<b>SERVICE BULLETIN</b>		
<b>To:</b> <b>For the attention of:</b> <b>Please copy to:</b>	<b>All Dealers</b> <b>Service Manager/After Sales Manager</b> <b>The Dealer Principal</b> <b>The Warranty Administrator</b> <b>Aston Martin Technician(s)</b> <b>The Parts Manager</b>	<b>Reference</b> <b>SB-08-0378</b>  <b>Issued:</b> <b>20 August 2013</b>
<b>Model:</b>	<b>V8 Vantage and V8 Vantage S (4.7 litre)</b>	
<b>VIN Range:</b>	<b>All 4.7 litre</b>	
<b>Subject:</b>	<b>New Friction Material for the V8 Vantage Clutch</b>	<b>Page 1 of 3</b>

Figure 1

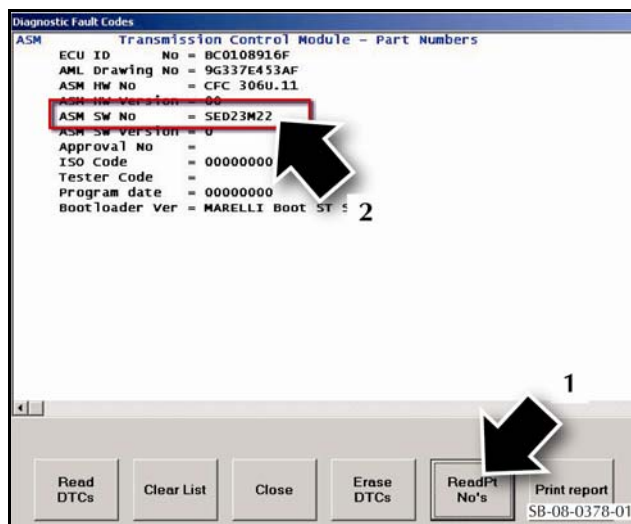
3. Use the AMDS to do a read of the ASM Transmission Control Module (TCM) part numbers (1) (refer to Figure 1).
4. For V8 Vantage S vehicles before VIN C15702, the correct software number is **SED23M22** (2). If the installed software number is different, use the AMDS to do an update of the ASM module software.
